SUBJECT: Responds to A Schwencer 790530 ltr requesting addl info re
 spend fuel storage capacity extension program. Submits
 revised pages to 781122 ltr re refined dimension of spent
 fuel rack storage cells.

Donald C. Cook Nuclear Plant Unit Nos. 1 and 2
Docket Nos. 50-315 and 50-316
License Nos. DPR-58 and DPR-74
Spent Fuel Storage Capacity Expansion Program

ATTACHMENT 1

Acceleration

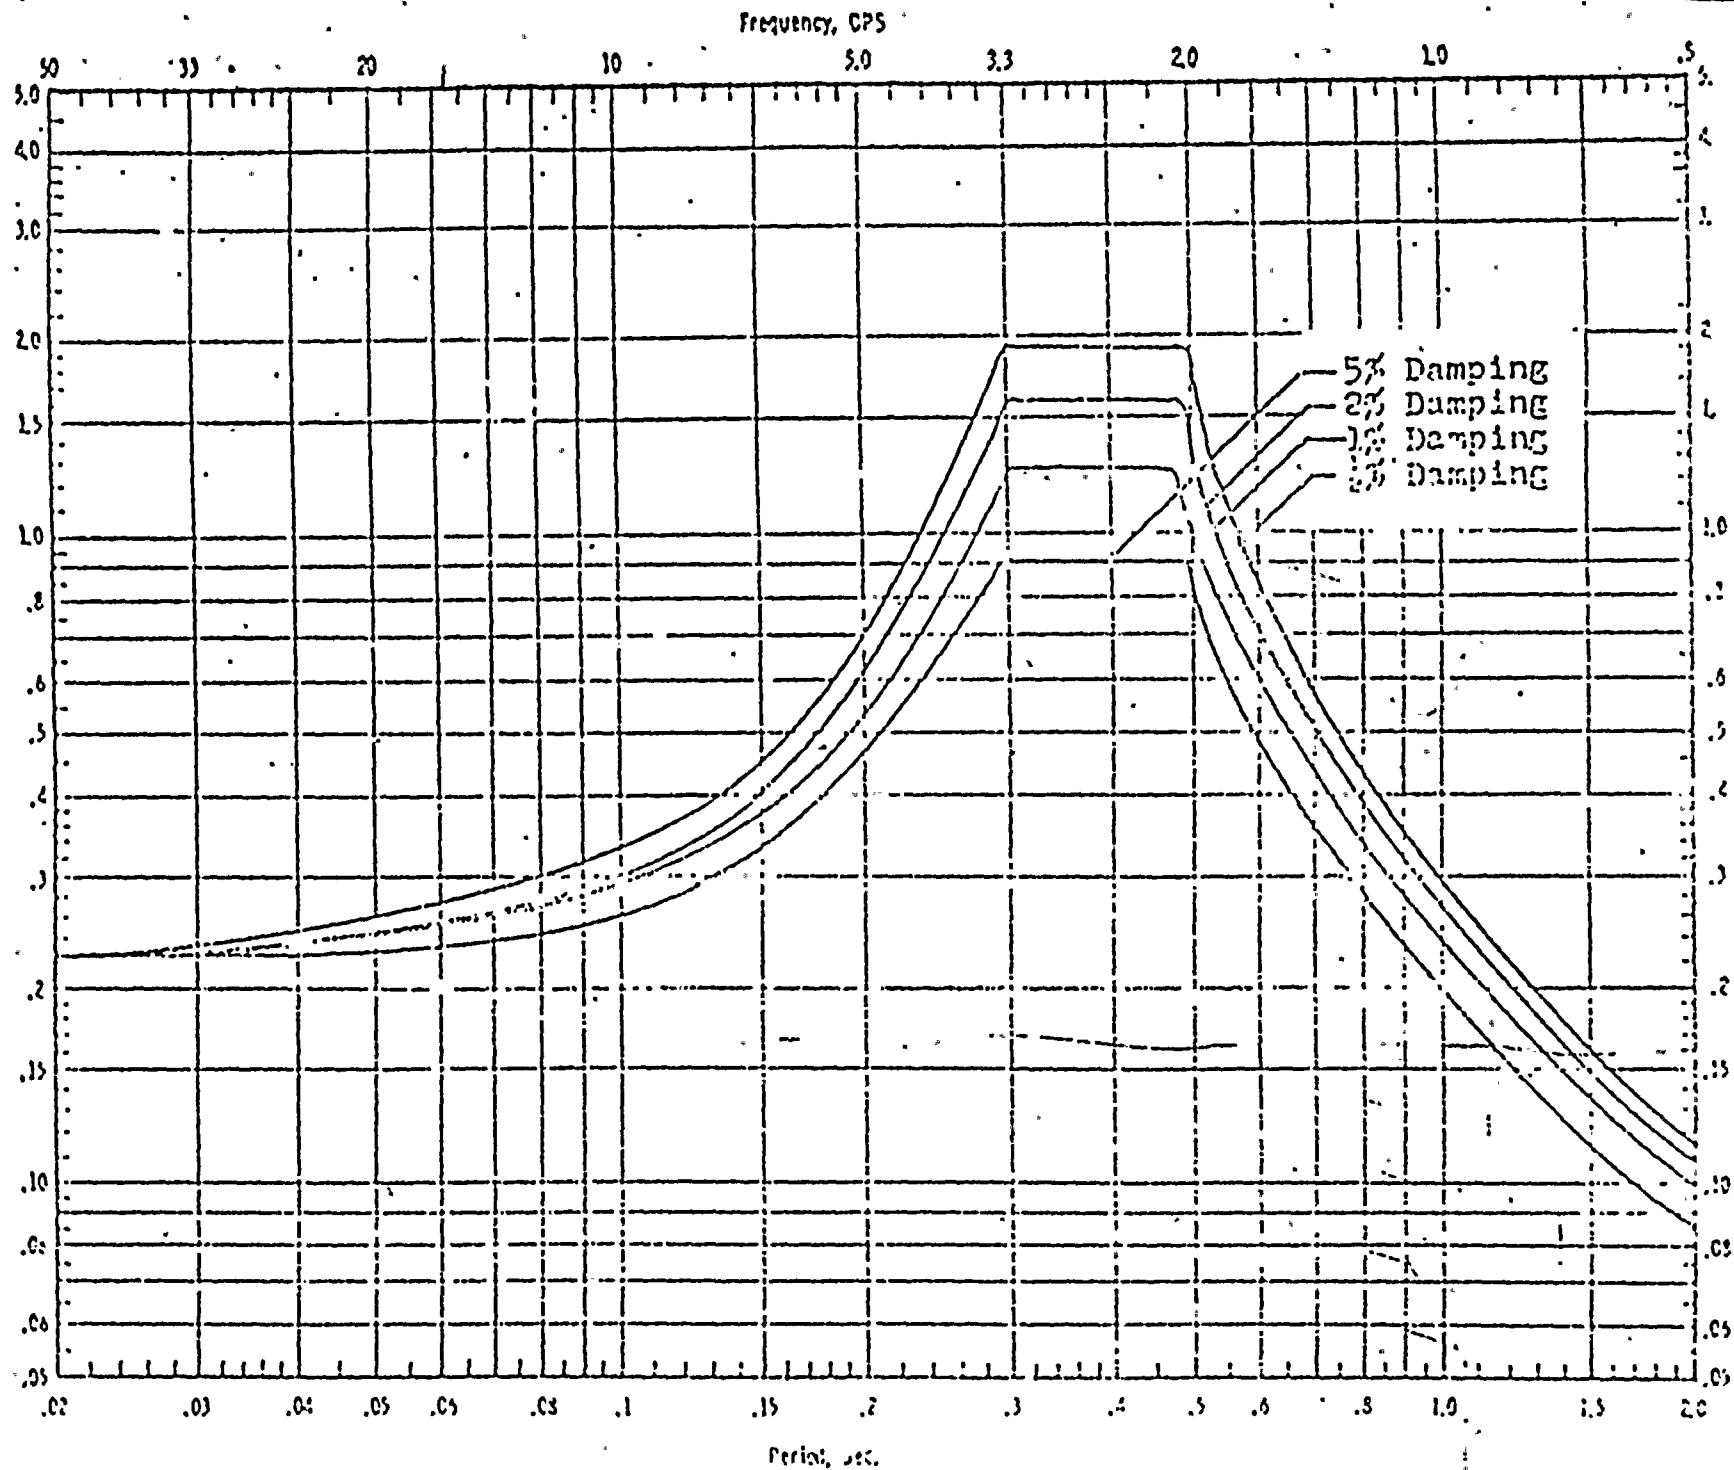
Provide details of the artificial time history showing a Fourier decomposition including a phase angle plot. Also, specify which floor response spectra was used in the analysis.

The floor response spectra used in the structural analysis is given in our submittal of April 16, 1979 Section 3.6.4.1 (sixth paragraph). For clarification the fuel pool floor response spectrum at El. 606' - 2½" was obtained by linear interpolation of the response spectra at El. 587' - 0" and El. 633' - 0". These floor response spectra were submitted to the NRC in Attachment IV of the response to the Seismic Qualification Review Team dated November 17, 1977, Docket No. 50-316, CPPR No. 61. Figures 3.6.7 through 3.6.10 are the floor response spectra used for interpolation.

FIGURE 3.6.13

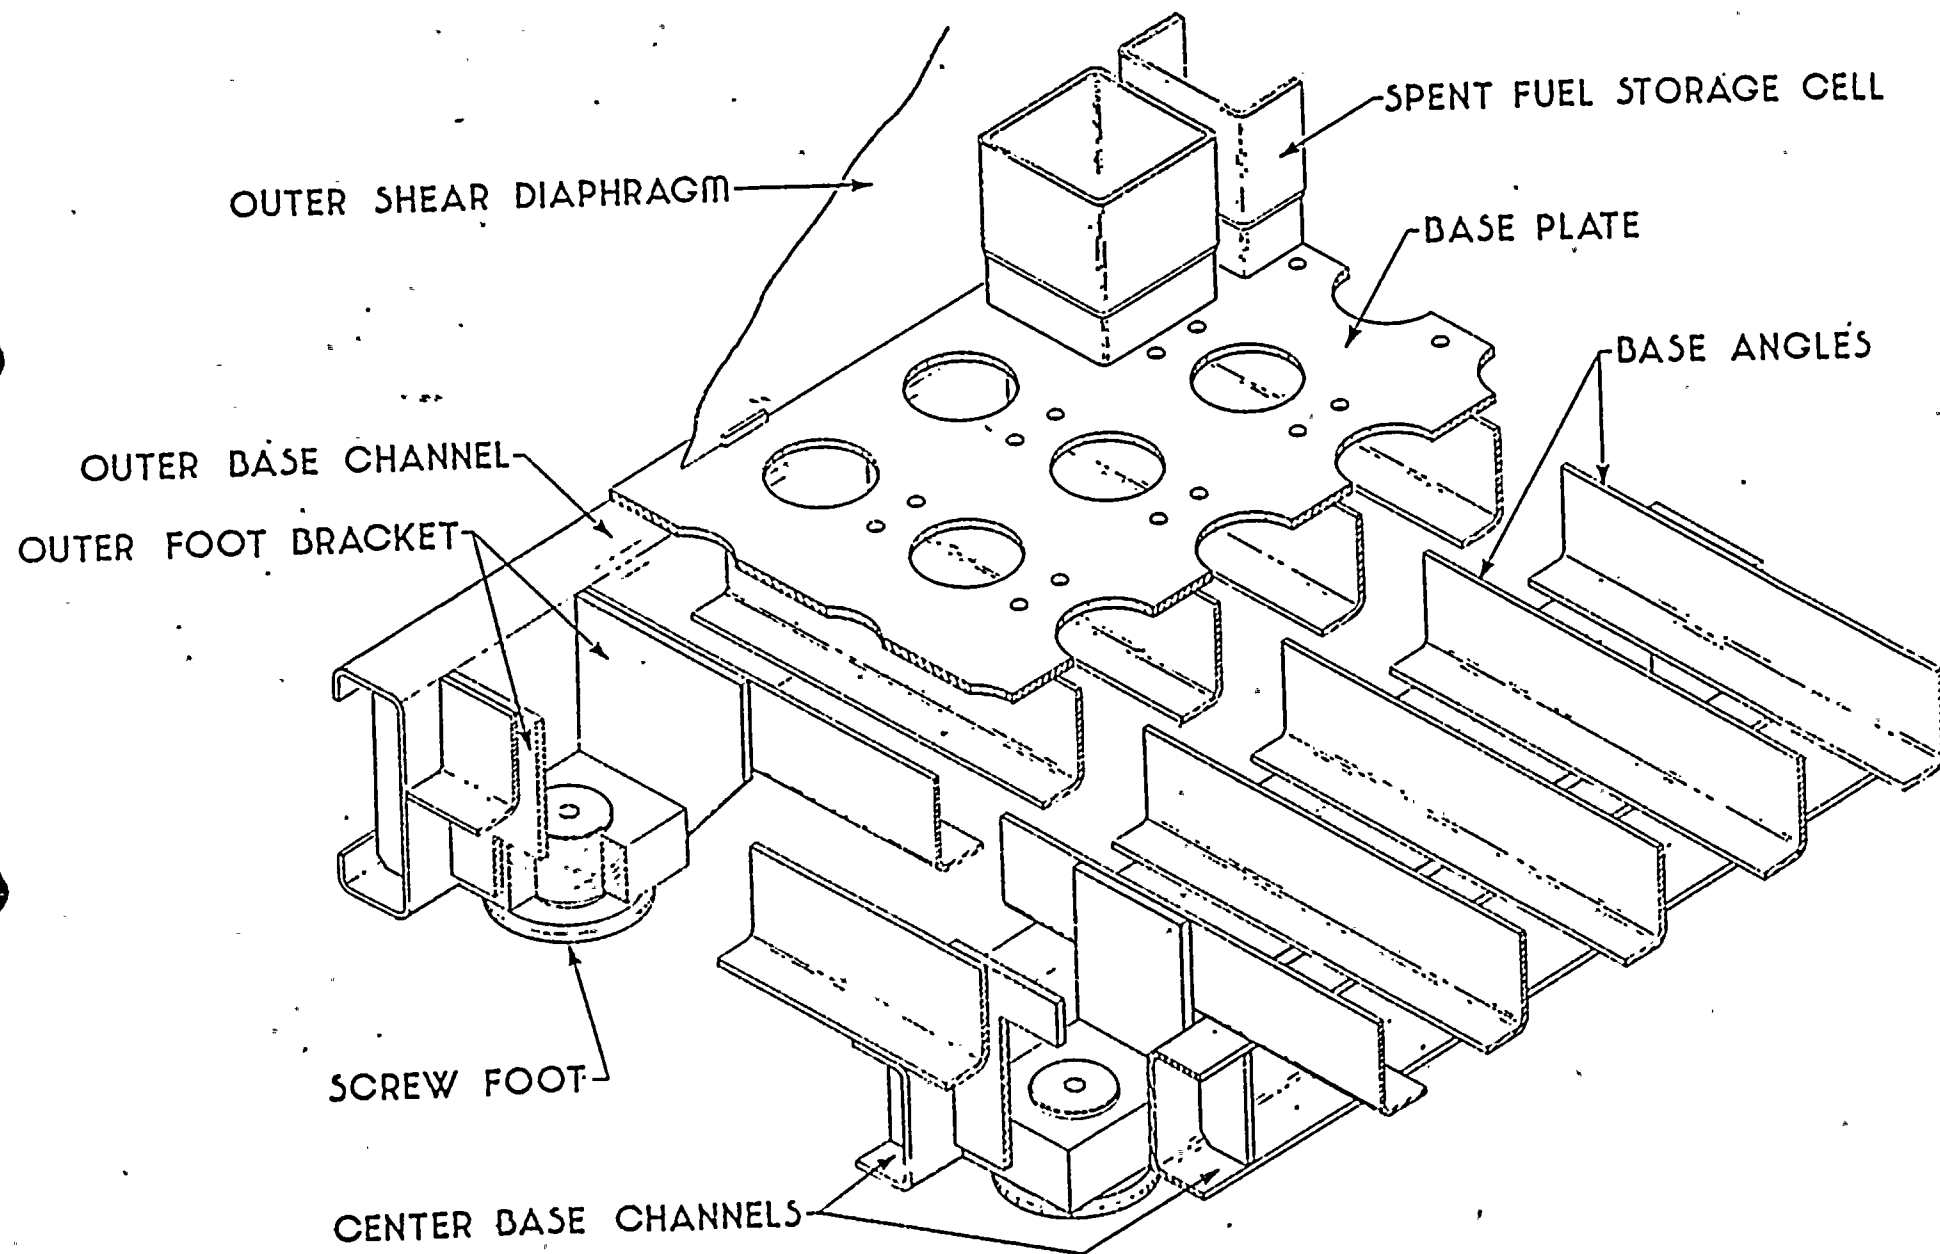
Provide details of the rack base and support feet.

The attached Figure 3.6.3 provides details of the rack base and support feet.
